USDA-SCS - FORT WORTH, TEXAS

FLOODWATER RETARDING DAM NO.8 SANDERSON CANYON WATERSHED PROJECT

As-Built Plans 3/30/78 JFB

Drawing No.
4-E-35,901

TYPICAL SECTION - EMERGENCY SPILLWAY

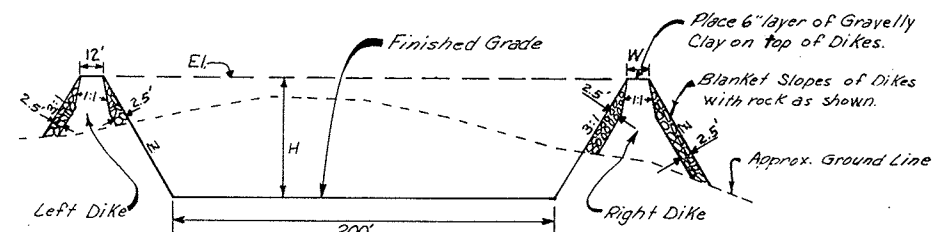
Left Dike: Sta. 7+80 to Sta. 8+00, Emergency Spillway Diversion is transitional to Dike Transition Dike from El. 3116.0 at Sta. 8+00 to El. 3123.0 at Sta. 9+00. Sta. 10+20 to Sta. 10+70, El. 3116.9. Sta. 10+70 to Sta. 11+50, Transition Section. Sta. 11+50 to Approx. Sta. 11+85, H=5.0'. As Built
